TEXAS DEPARTMENT OF TRANSPORTATION

MINOR DESIGN UPDATES UNDER CONSIDERATION FOR FINAL DESIGN

CROSS STREET IMPROVEMENTS

CR 317

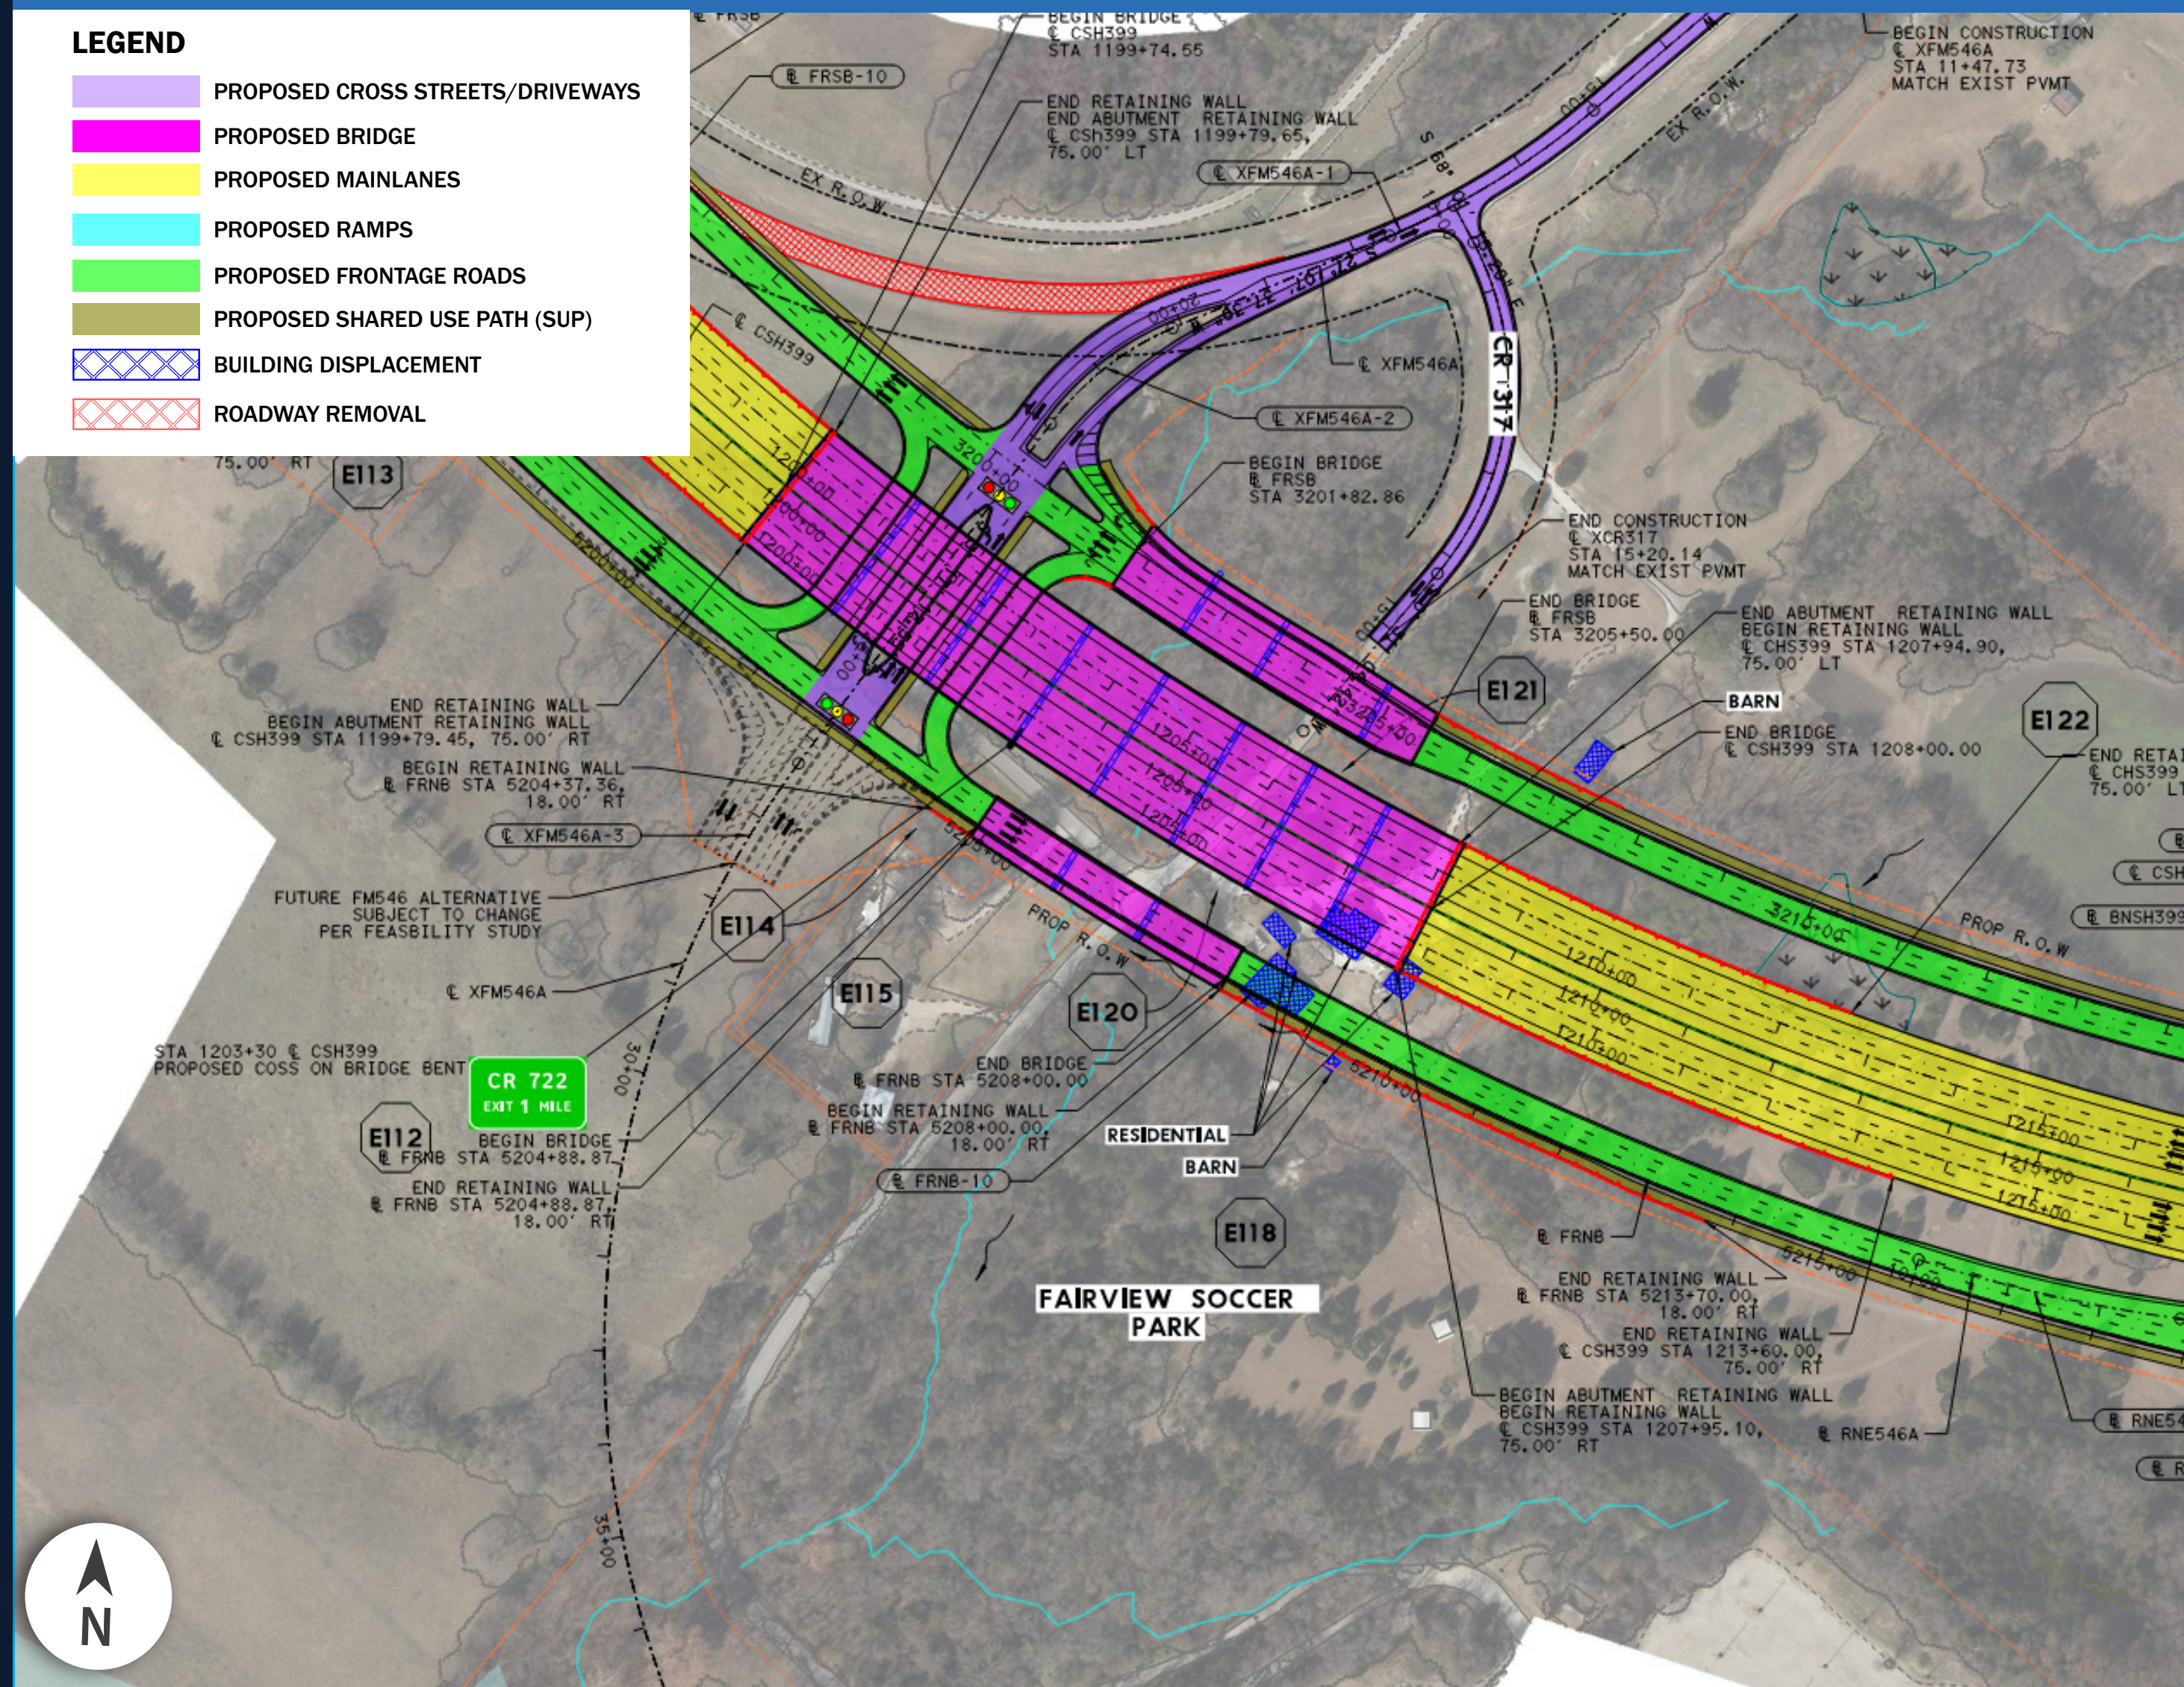
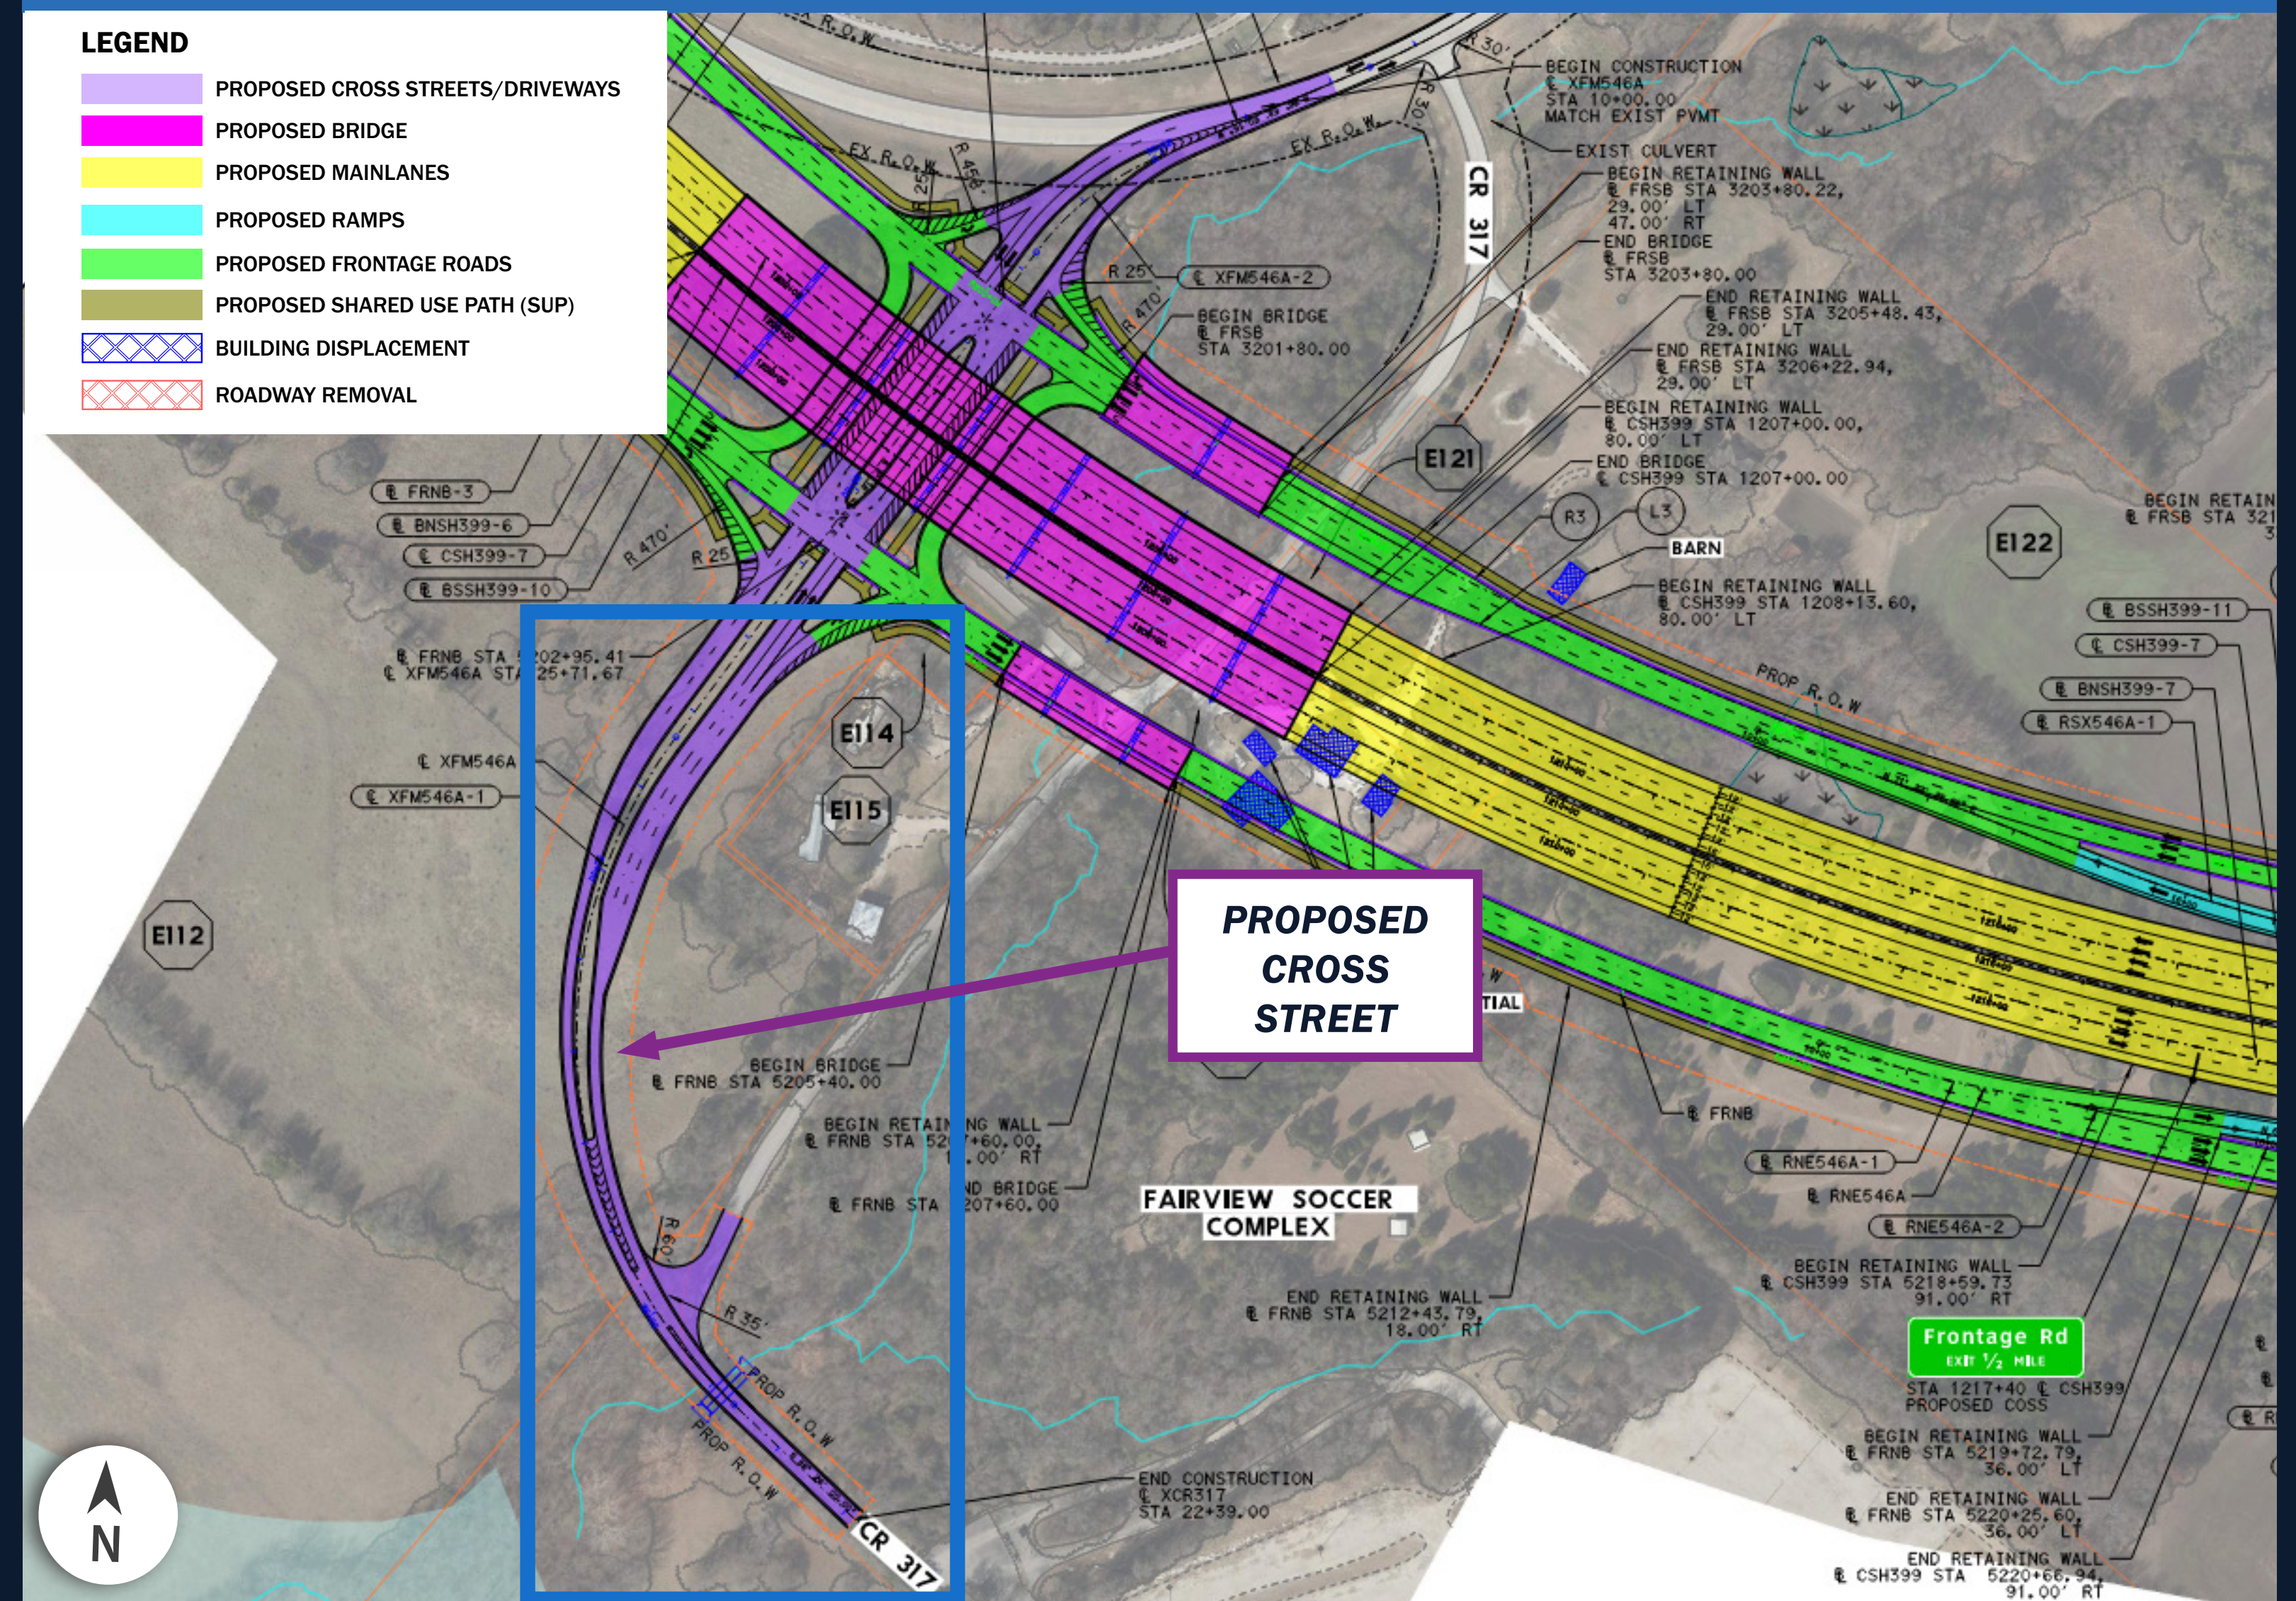
At CR 317, the proposed design would remove existing CR 317 within the proposed ROW. The future 546 interchange improvements being planned by Collin County would serve the north and south movements for CR 317.
